01/26/2026

**ADDENDUM NO. 3  
TO CONTRACT DOCUMENT PLANS SPECIFICATIONS**

**PROJECT: MWA METRO PARK WEST LANDFILL  
P-67 CELL E LINER, LEACHATE LAGOON, AND SED POND**  
**TO: PROSPECTIVE BIDDERS AND OTHER INTERESTED PARTIES**

## MWA PROJECT P-67

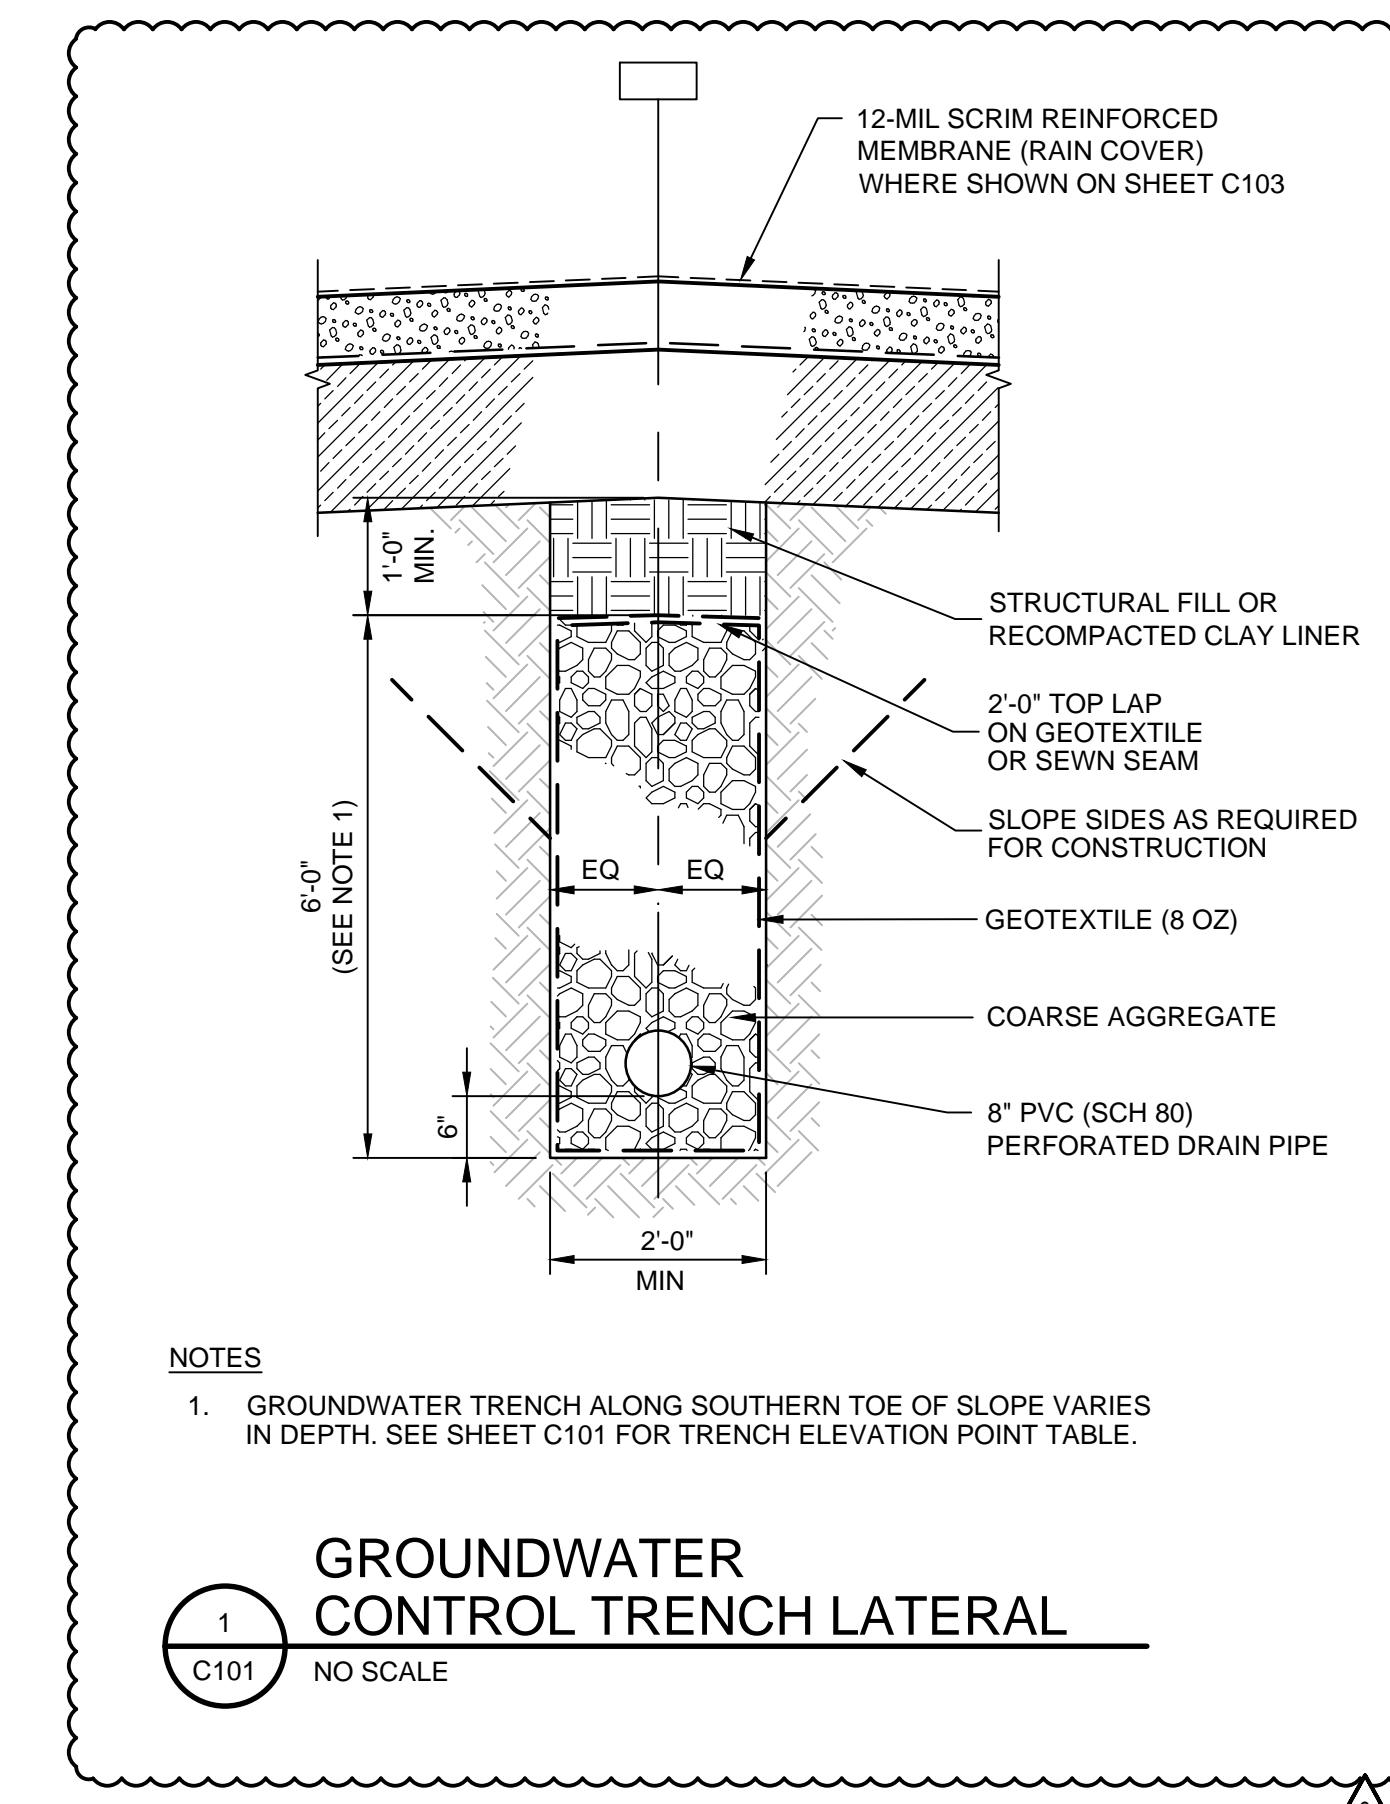
**Question 3:** *Detail 5, sheet C506 outlines nylon rope requirements for sandbag ballast placed on the slopes. Is nylon rope required for bags placed on cell floor to prevent movement of sandbags by adverse weather?*

**Answer 3:** Install  $\frac{3}{4}$ " UV resistant Nylon rope for slopes and floor of Cell E. See revised Detail 5 and on Sheet C506.

**2 LEACHATE LOAD-OUT AREA SECTION**  
C104 NO SCALE

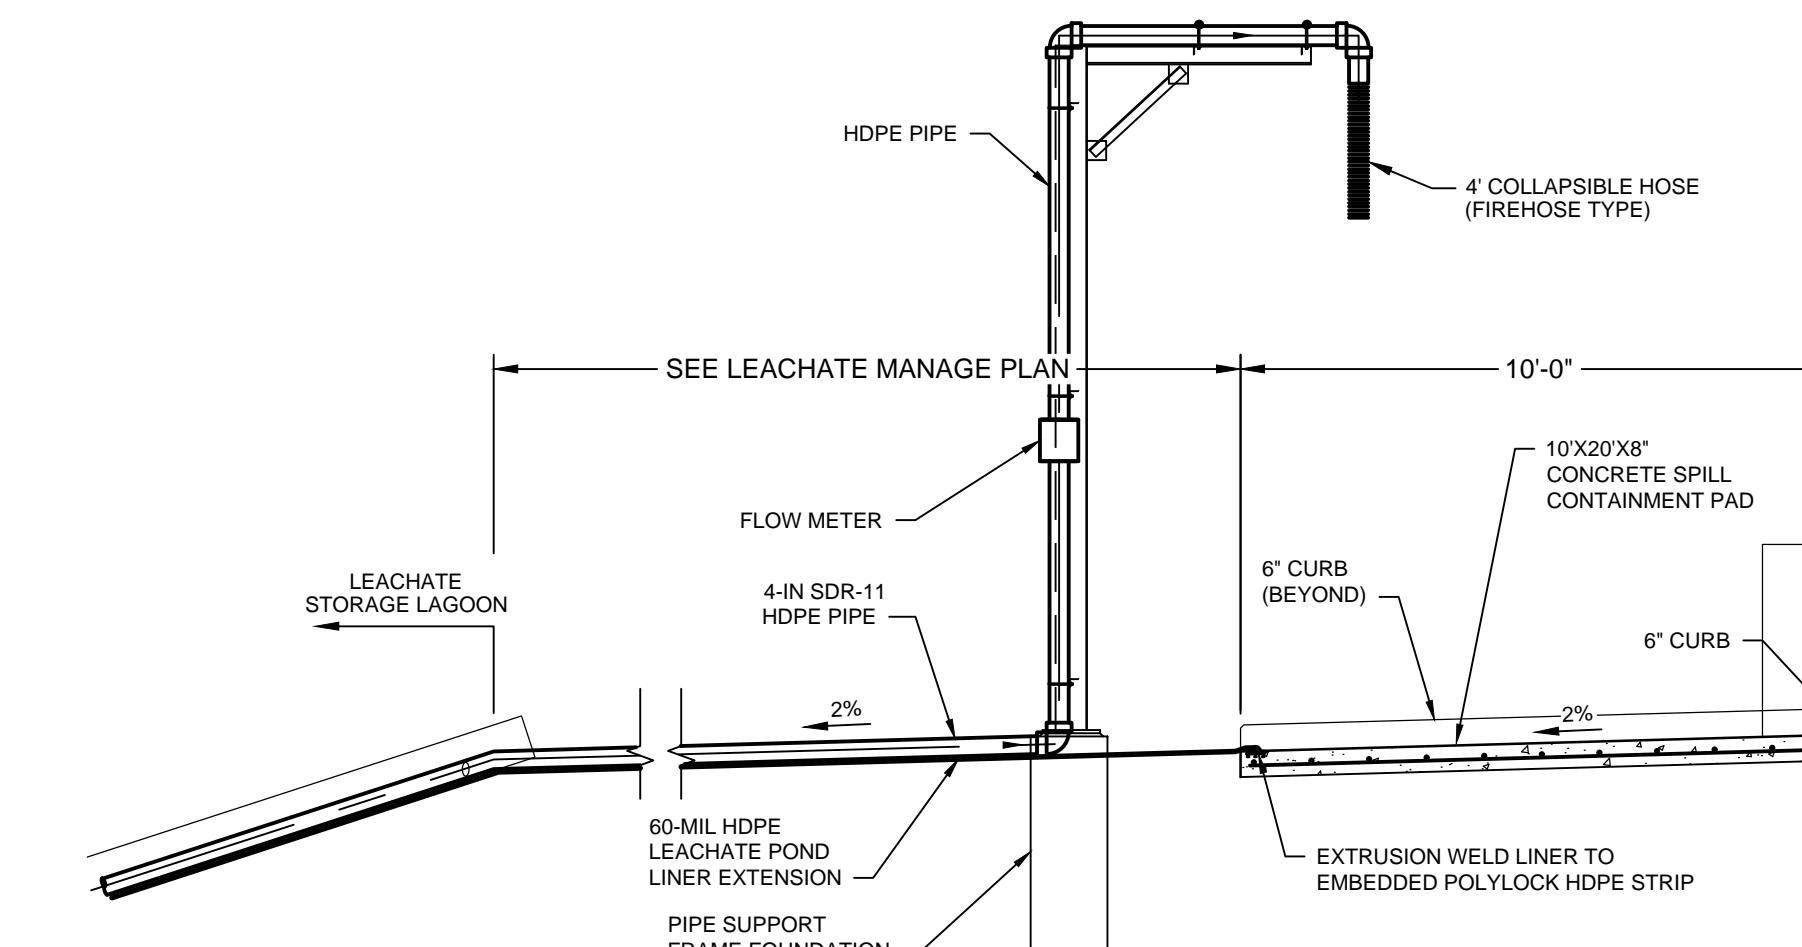
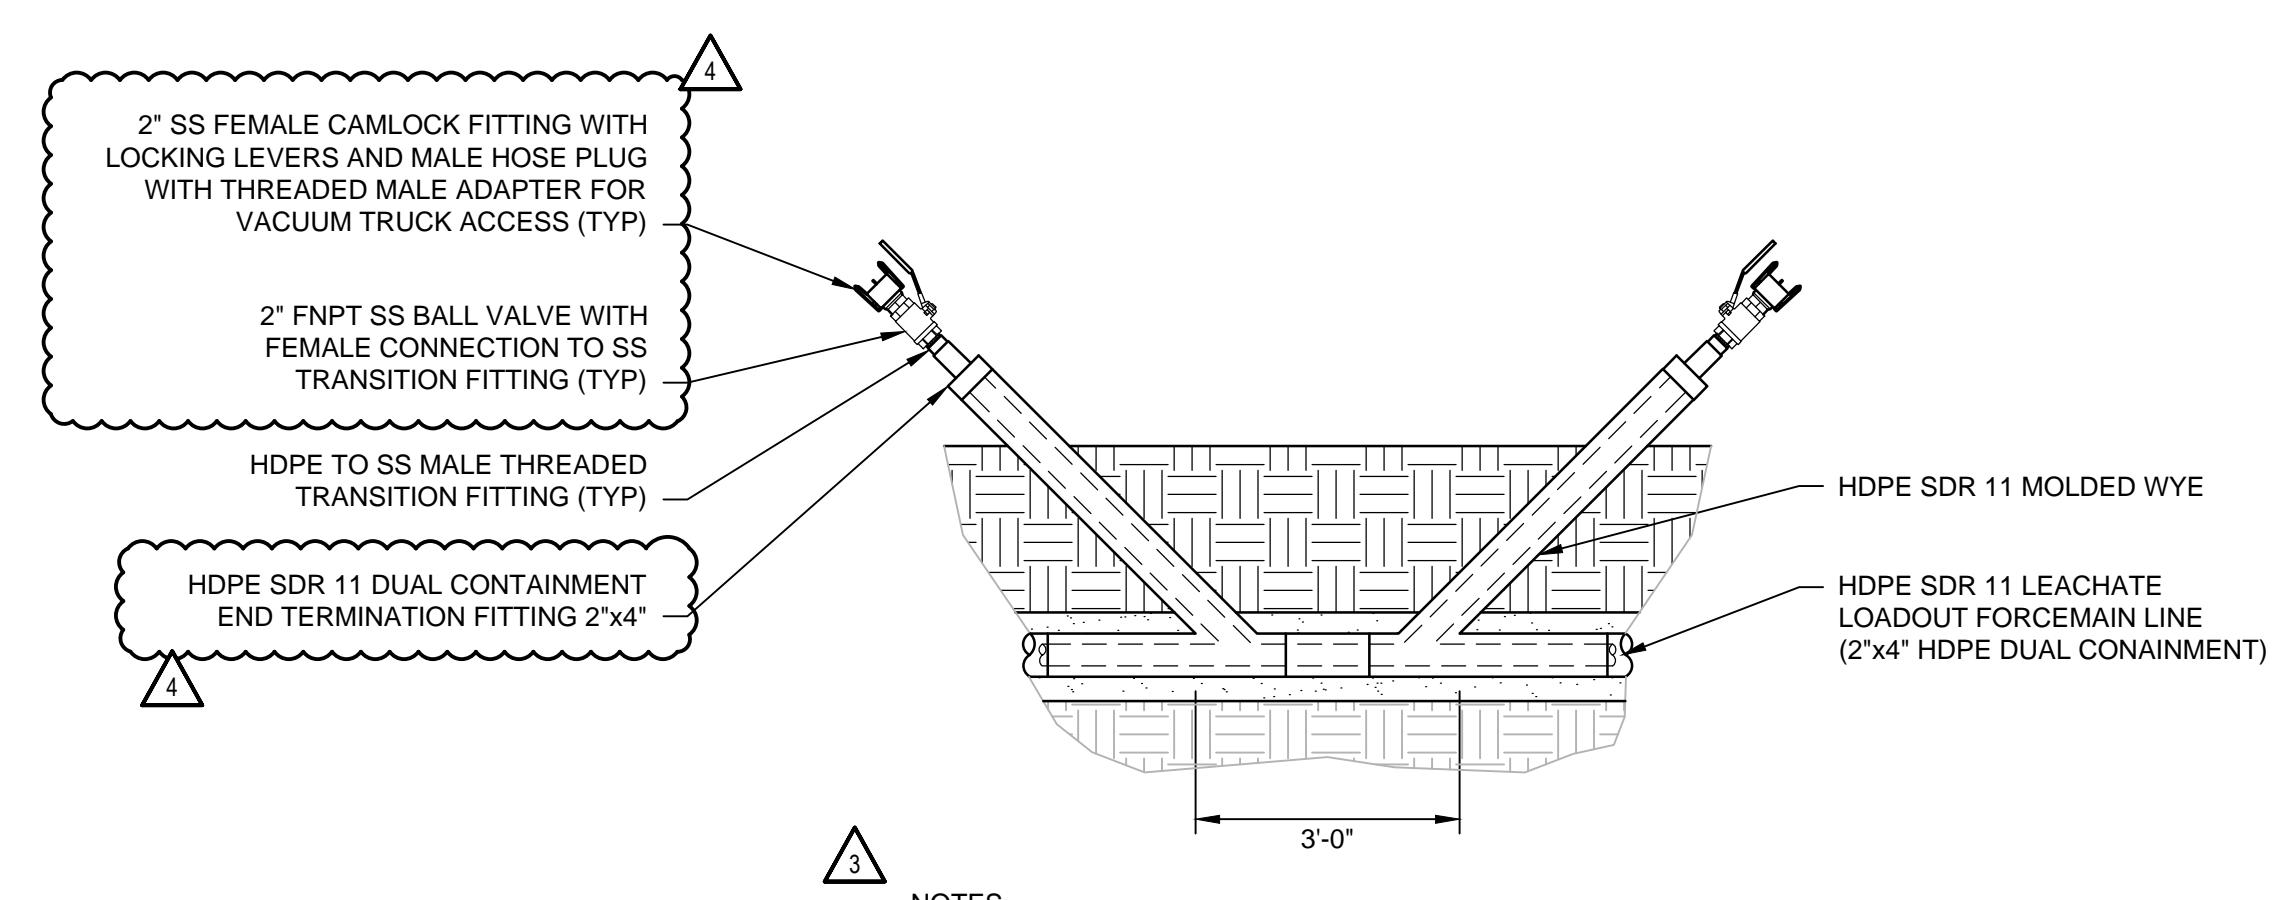
**Question 5:** *Leachate Lagoon Loadout, how is it intended to be pumped out of the lagoon? Is the pump direct rolled down the liner? Does it have a riser pipe? Does it require a headwall?*

**Question 16:** Sheet 508, detail 2, Pipe coming from the Pond to the Loadout Area is called out as 4". Question #1 from add. #2 changed it to 2" x 4"?

**Answer 5:** Leachate loadout pumped will be connected to a 4" HDPE pipe and housed in a 24" SDR-11 HDPE extraction riser. See sheet C508 for further clarification.

**Answer 16:** Piping within the lined area of the Leachate Pond for supplying the Leachate Loadout shall be 4" SDR 11 HDPE piping per Detail 2 on Sheet C508.
